Appendix E

Preliminary Acoustic Investigation

Re: St Patrick's School, Macksville - Traffic Noise Impacts

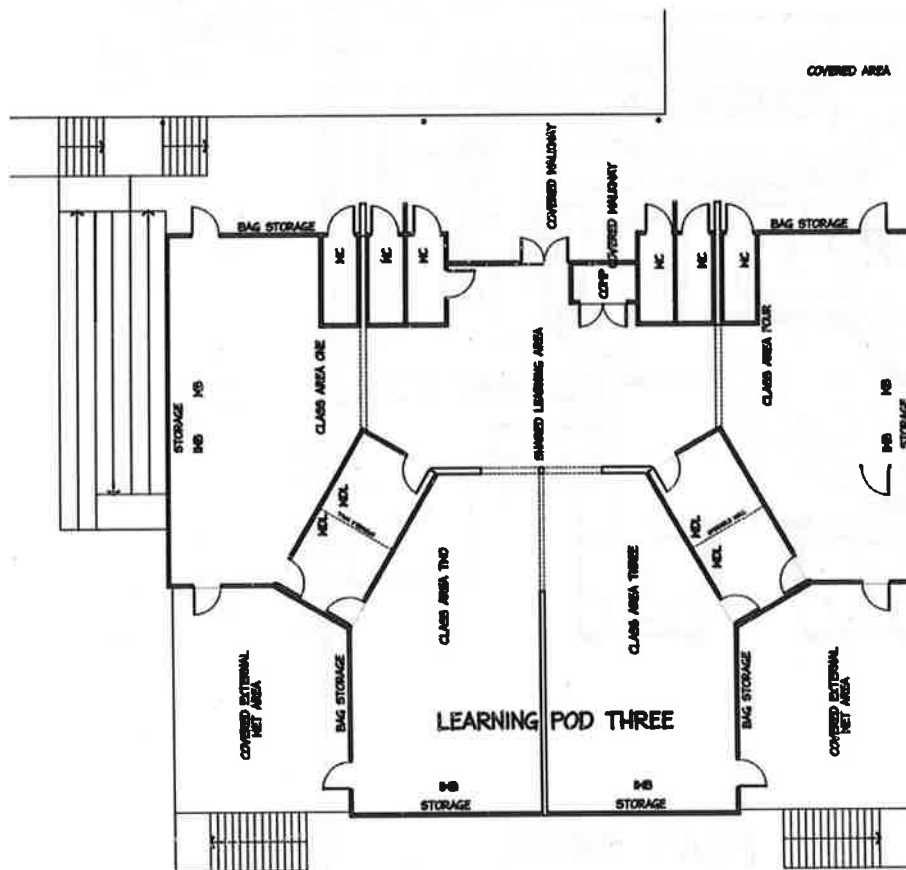
The proposed building layout is shown below. Building A is admin offices, B is a community hall and C, D, E and F are classrooms. There is a proposed future early learning building near the east boundary. The nearest building is approximately 410m from the proposed Highway.

At the propsed set back, we do not consider traffic noise in general outdoor play areas will be an issue. However, we note a propsed outdoor learning area which is positioned as far away as practicable towards the western side of the site and then associated with each classroom is a covered outdoor learning area. Some impacts from traffic noise may be encountered in these areas.

Ideally, in planning the school it would be preferable to use school buildings other than classrooms (administration, school halls etc) to shield these outdoor learning areas as much as practicable. It is also desirable to try and use the classroom buildings to provide shielding to quieter "courtyard" areas beyond. However, with such a relatively large site this may not be ideal for other reasons.

For classrooms closest to the proposed highway it may be sensible to reorient the classrooms which have the outdoor learning areas facing east towards the road, subject to issues like solar access.
